SHOVON KNITWEAR LTD (Extension)

West Masdair, Fatullah,, Narayangonj
(23.626566, 90.486408)
12 April 2023

Buildings Information

Observations

Fig: Pictorial evidence of Crack -1

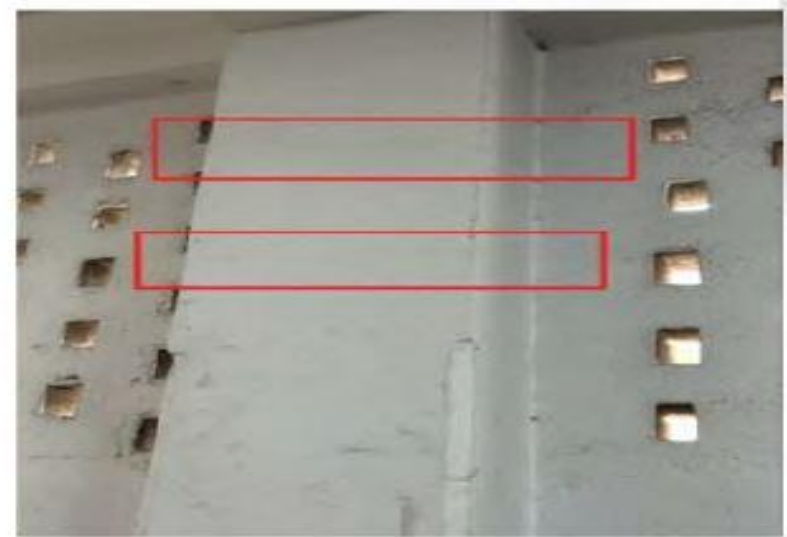
At the time of inspection, crack was found on column surface in ground floor at marked location (see layout). The factory must immediately engage a consultant to investigate the extent and reason of cracks, prepare a detailed investigation report with proper remediation methodology and submit to RSC for review.

Horizontal crack shown on column in Investigation report

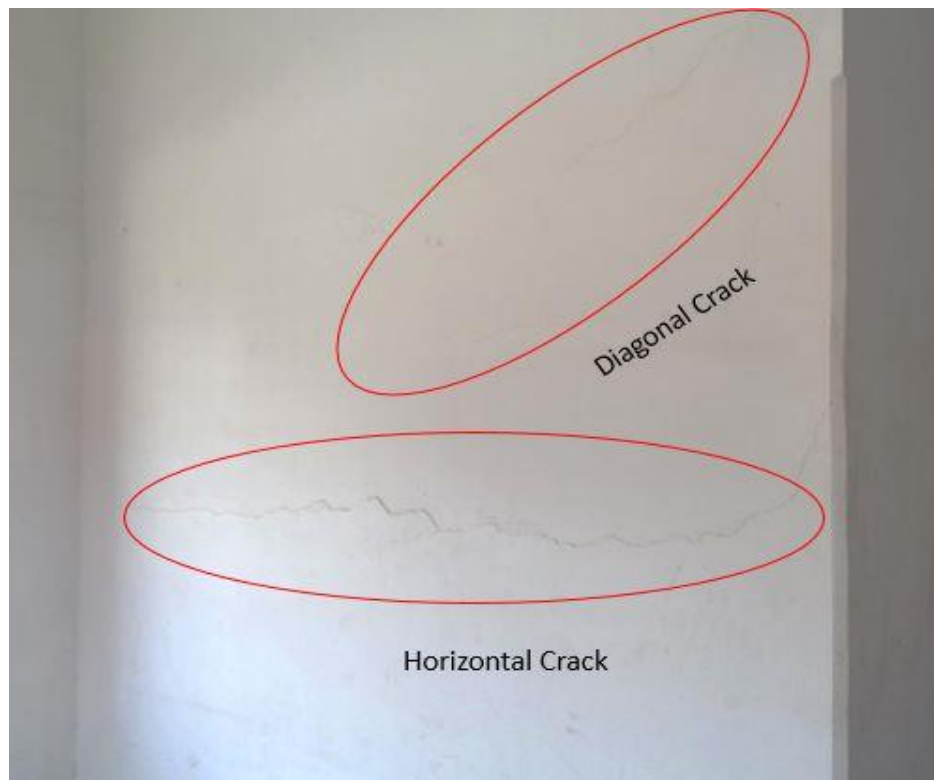
A crack investigation report was available on site, which shows horizontal cracks in two columns at the ground floor. However, those cracks in columns have been locally repaired by plaster and paint. Further, in the investigation report those cracks were mentioned as structural cracks without chipping the cracked surface. The factory must immediately engage a consultant to investigate the cracks in depth, prepare a detailed investigation report with proper remediation methodology and submit to RSC for review.

Rooftop Shed-1

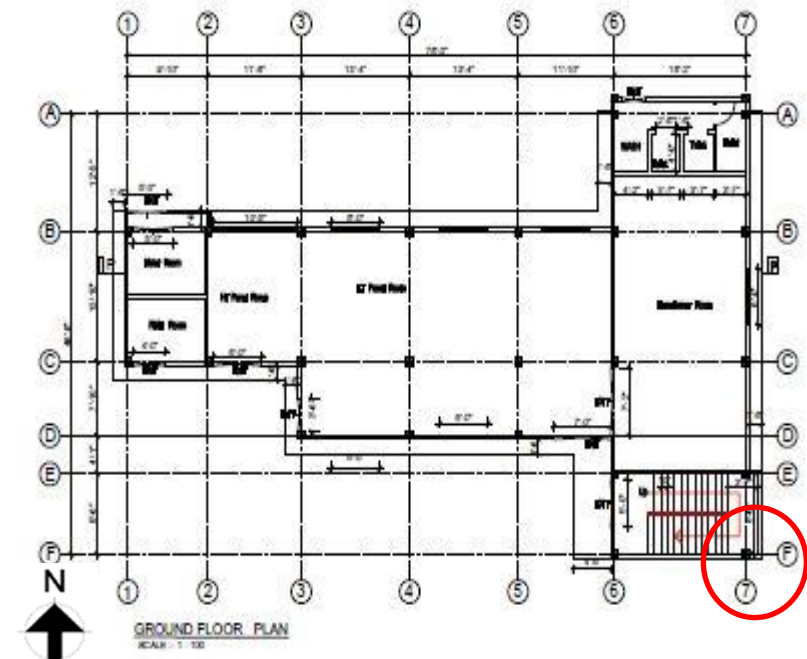
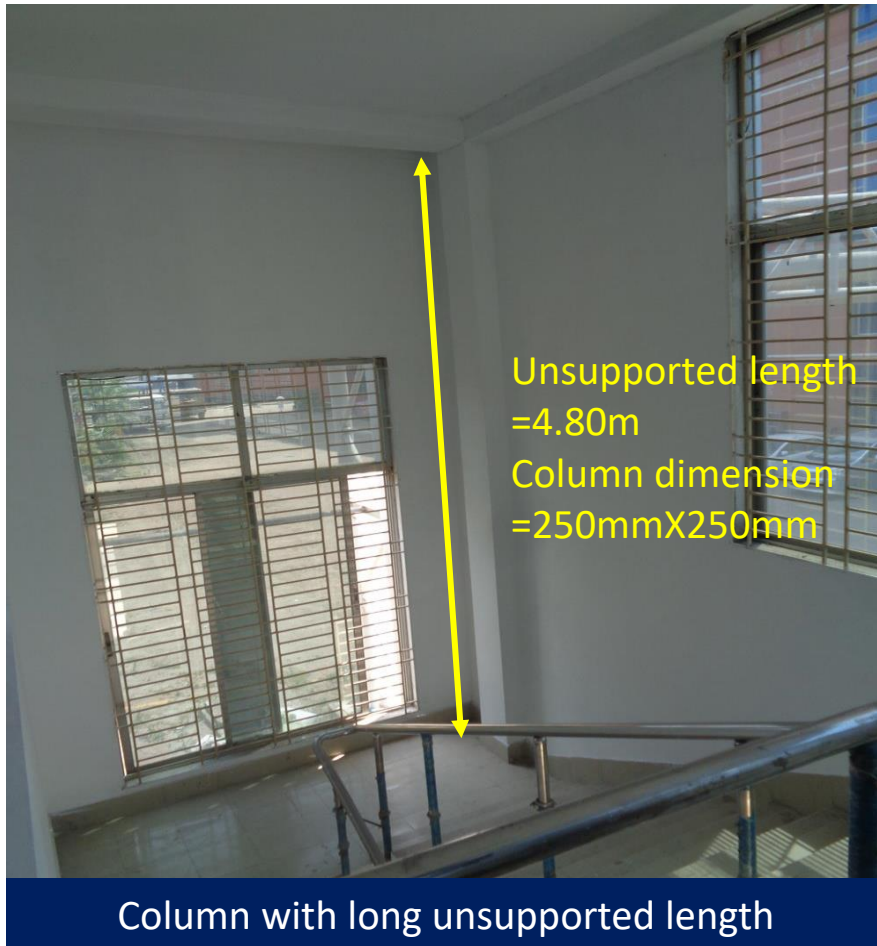
Both Shed-1 and Shed-2 were appeared to be non engineered due to lack of lateral stability system and apparently inadequate member sizes. The building engineer is required to check the lateral stability of the sheds against lateral forces.

A tie beam in short direction only at one grid

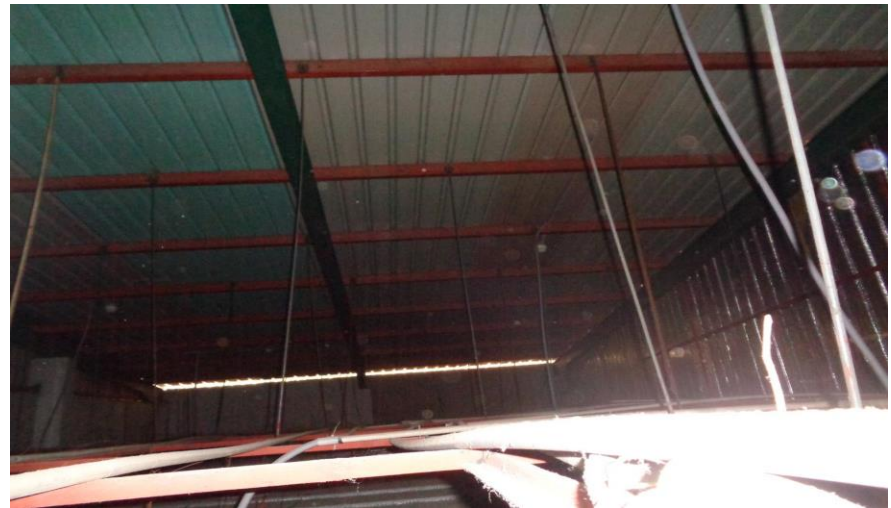
A tie beam is provided in short direction only at one grid. Tie beam is not provided along the long direction where the unsupported eave height is 5.48 m. Also, no bracing system is provided to resist the lateral loads. Building engineer is required to check the lateral stability of the shed and suggest proper remedial measure accordingly (where required).

Structural connection with adjacent shed

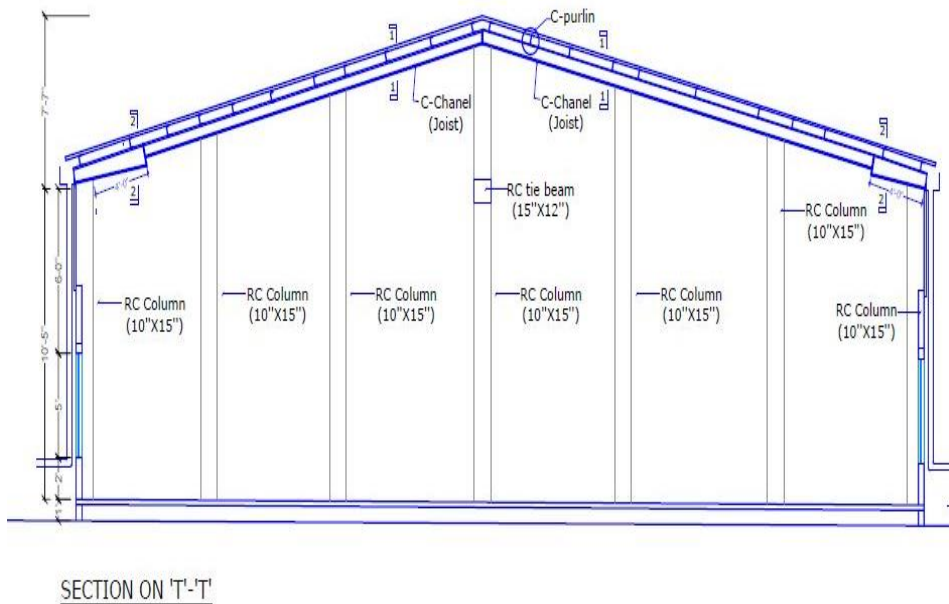
The shed is structurally connected by beam with another shed. Building engineer is required to consider the lateral connections with adjacent shed during the structural analysis. And carry out remedial action if suggested by the building engineer.
